STATE OF HAWAII
DEPARTMENT OF LAND AND NATURAL RESOURCES
Engineering Division
Honolulu, Hawaii 96813

**Request Approval of Variance for Keaīwa Reservoir (HA-0049) of Hawaii
Administrative Rules Section 13-190.1-21(b)(2), and allow more than 5 feet of Water depth
to remain in the Breached Dam**

Dam Owner: Edmund C. Olson Trust No. II
P.O. Box 280
Pahala, HI 96777

Location: Middle & Lower Moaula Camp, Pahala, Hawai'i County

Figure 3. Typical section of proposed dam breach.

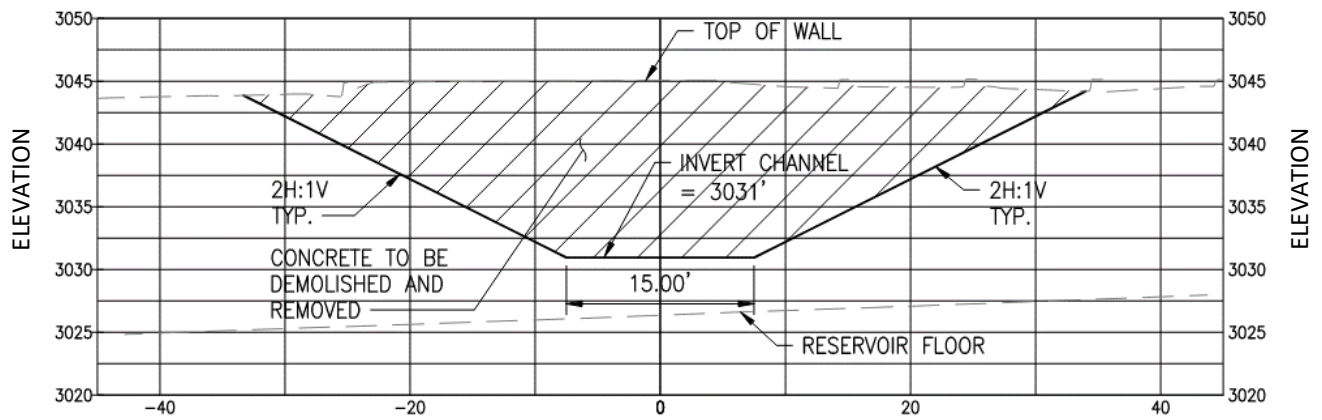
The Owner is proposing to modify the dam by creating a trapezoidal shaped channel through a portion of the southwest embankment wall (see Figure 3), which will lower the effective height and storage capacity of the dam. The intent is to partially remove the dam to bring it below the jurisdictional thresholds. The effective height of the dam structure will be reduced from 32-ft to 23-ft and the storage volume is greatly reduced from 48 acre-ft (16 million gallons) to 18.5 acre-ft (6 million gallons). The engineered breach is conservatively designed, having several times the capacity to pass a Probable Maximum Flood (PMF) event.

During a 100-year flood, the remaining pool in the reservoir will be 23-ft deep¹, which exceeds the five feet maximum depth in HAR §13-190.1-21(b)(2):

The Department recommends the Board to authorize a variance of HAR §13-190.1-21(b)(2), to allow a breach of the Keaīwa Reservoir (HA-0049) that will have a reservoir depth of not more than 23 feet of water and the maximum reservoir storage will not exceed 18.5 Acre-Feet.

Figure 4. Dam breach inundation map, maximum depth plot.

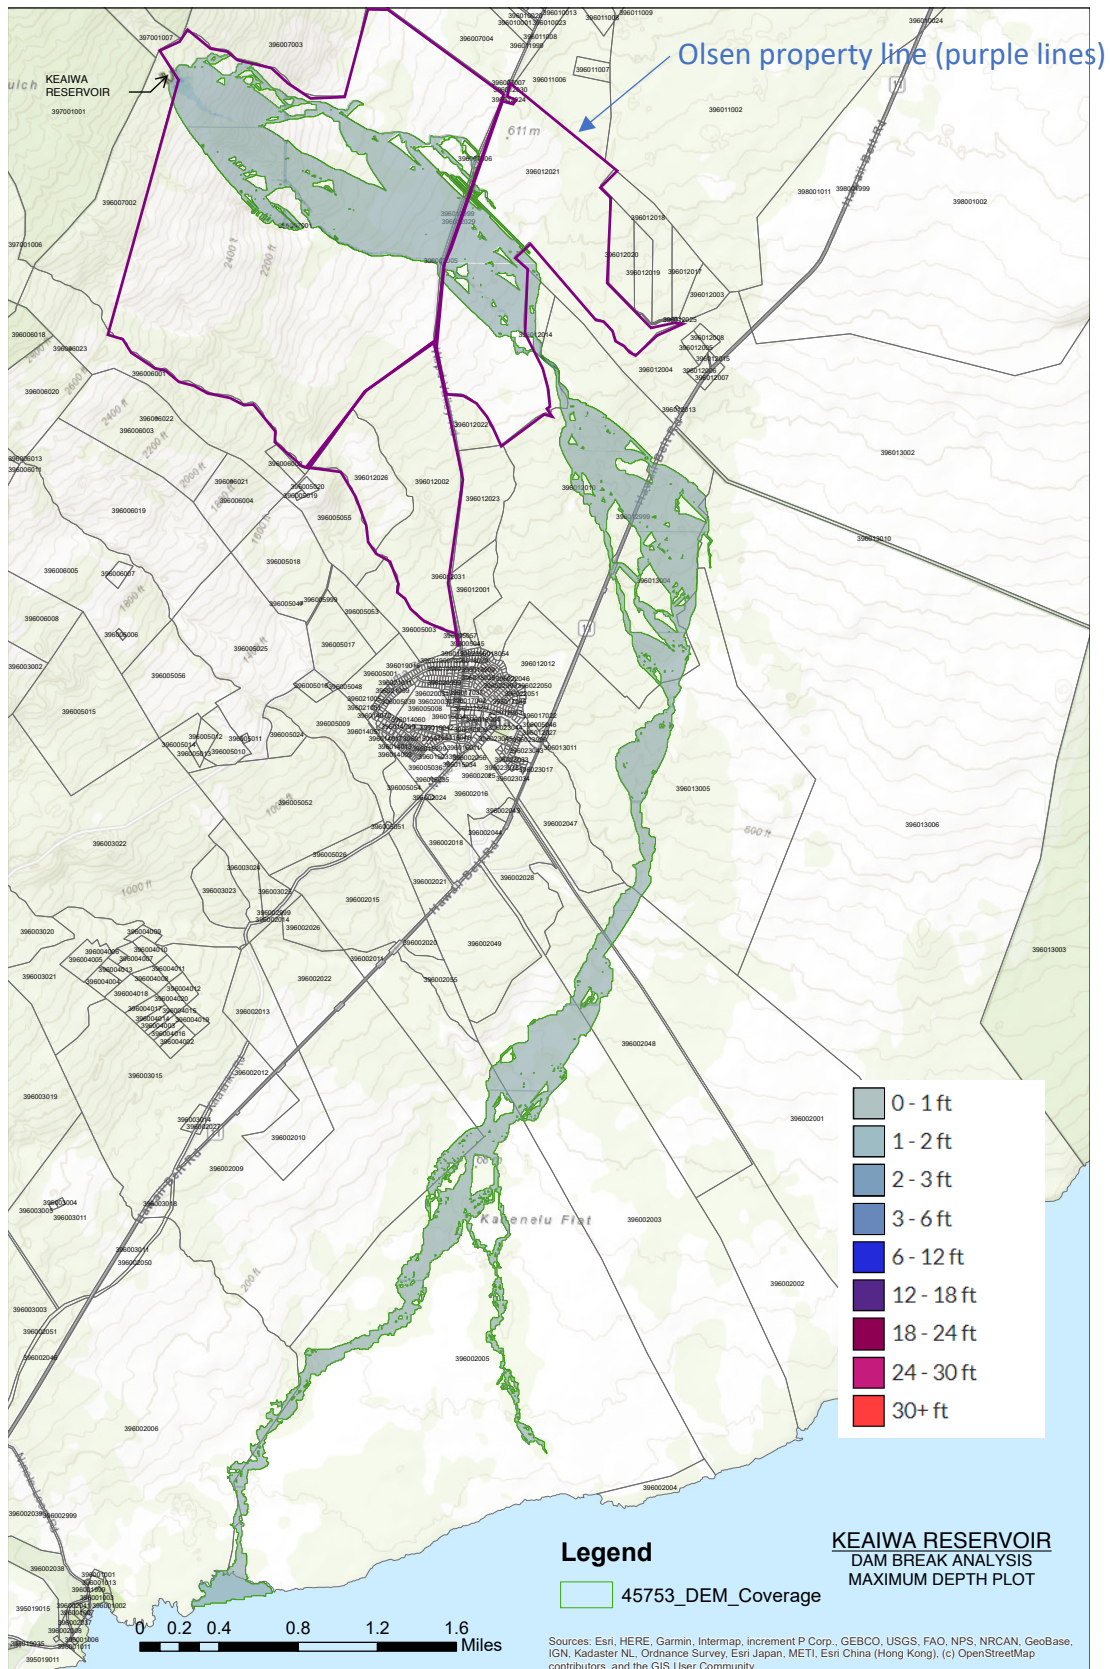
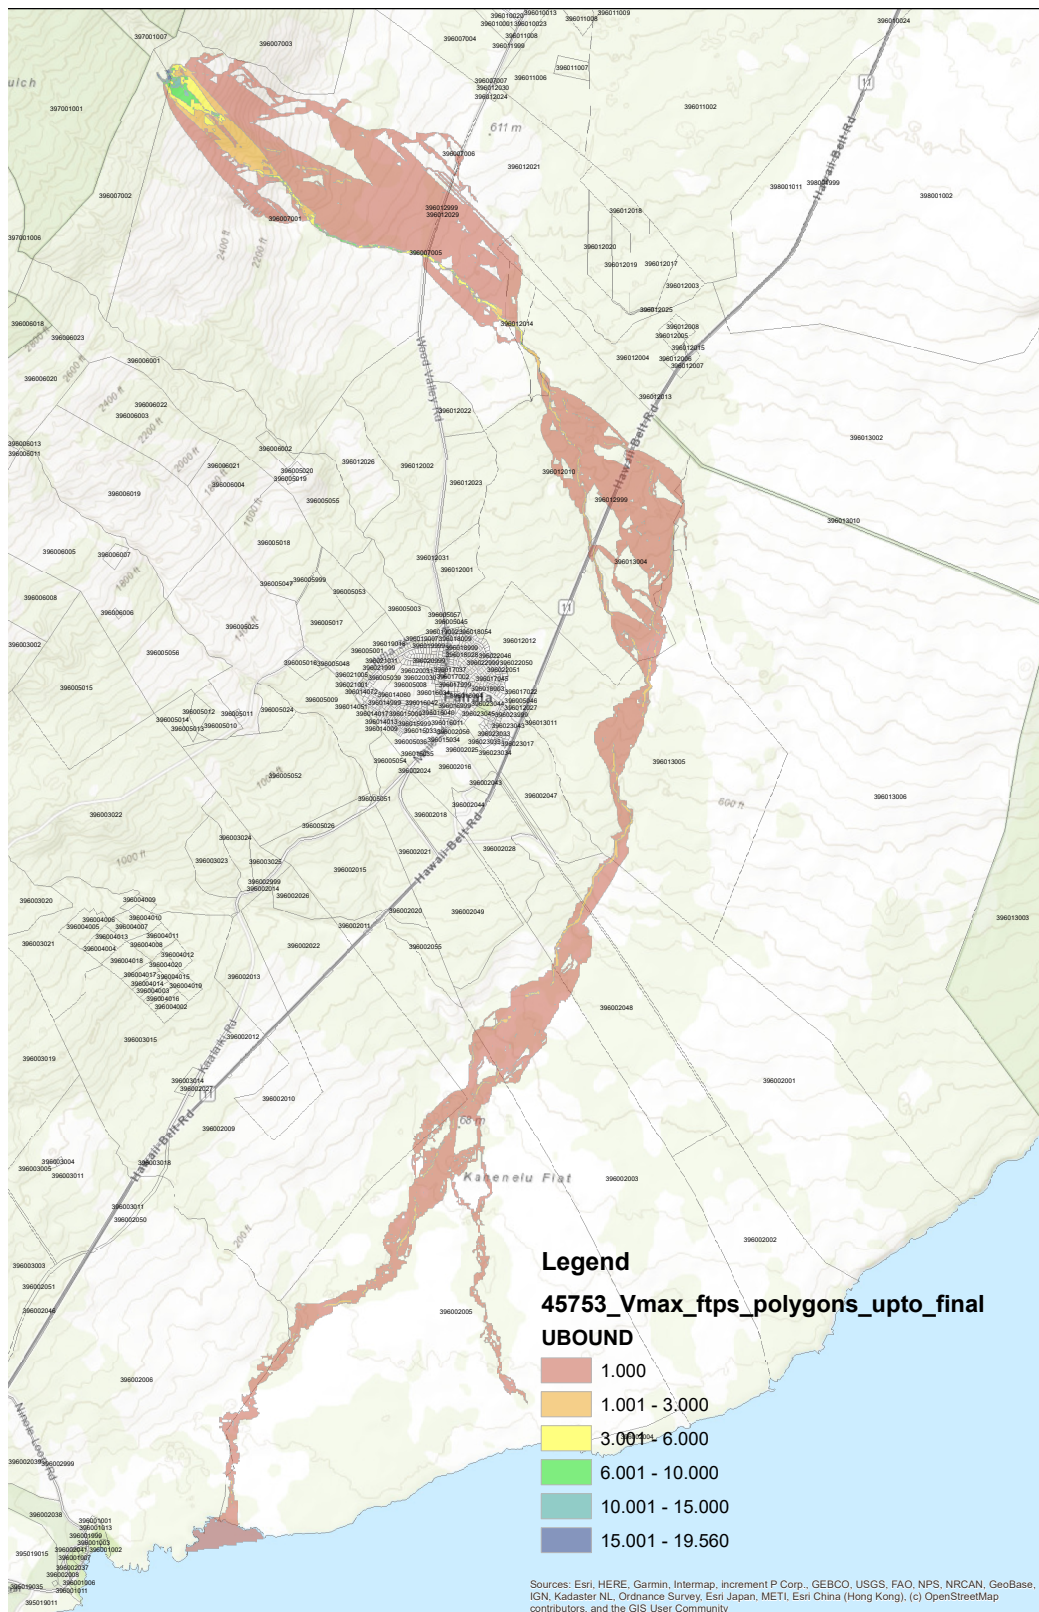
A dam breach (failure) analysis was performed with the reduced reservoir storage volume and determined the modified dam's failure would generate a peak water flow rate of 1 foot per second at a depth of 1-2 feet and is primarily contained within existing drainageways. The flow route is displayed on the inundation map maximum depth and maximum velocity plots on Figures 4 and 5, respectively. With the modified dam holding close to three times less water in the reservoir, the downstream flow is greatly reduced.
